blackmer

UPGRADE 101-990

SECTION 101
EFFECTIVE NOV 1988
REPLACESRIGHT HAND ROTATION. FOR LEFT HAND ROTATION,
SHAFT PROJECTION IS OPPOSITE THAT SHOWN.XL4 TO REPLACE OLD MODELS (A)(T)X3 1/2 PUMP *

*USE IN CONJUNCTION WITH
XL4 DIMENSION PAGE 107/105

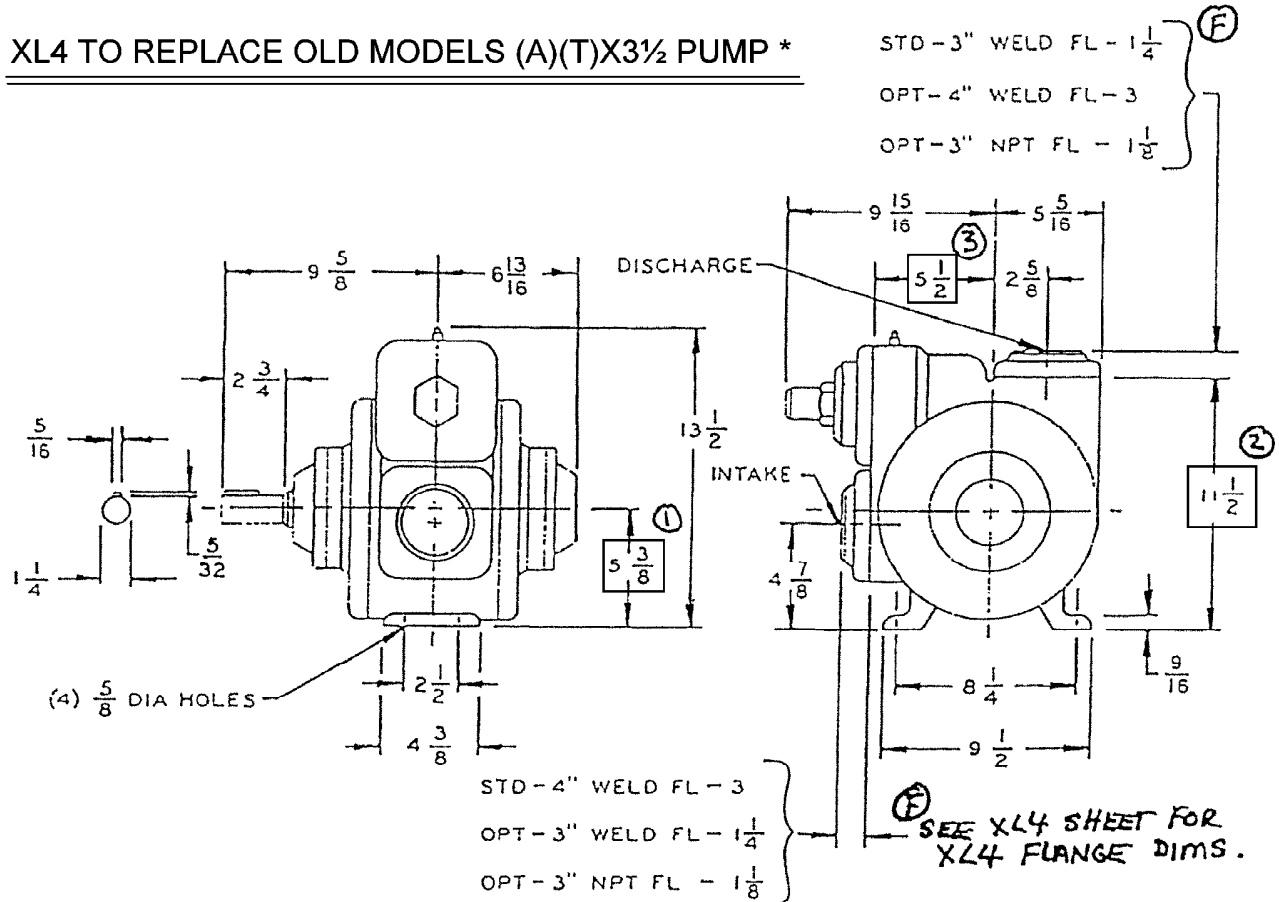
(A)(T)X3 1/2	XL4	DIFF. XL4 TO X 3 1/2
① Shaft center-line (coupling)	5 3/8 in.	5 15/16 in.	Plus 9/16 in.
② Height to discharge port	11 1/2 in.	13 7/16 in.	Plus 1 15/16 in.
③ Centerline to inlet port	5 1/2 in.	6 9/16 in.	Plus 1 1/16 in.

>> Best method to replace X3 1/2 with XL4

- Shim the motor and reducer up 9/16 in.
- Shorten (adapt) suction / discharge pipe connections. XL4 comes standard with 4 in. weld neck flanges. Optional 3 in. weld neck flanges avail.
- ** Pipe alignment remains the same other than requirement to shorten (reconnect) to new pump.

-->> Pump performance regarding flow and power same between both pumps.
- Based on same speed, viscosity and pressures.
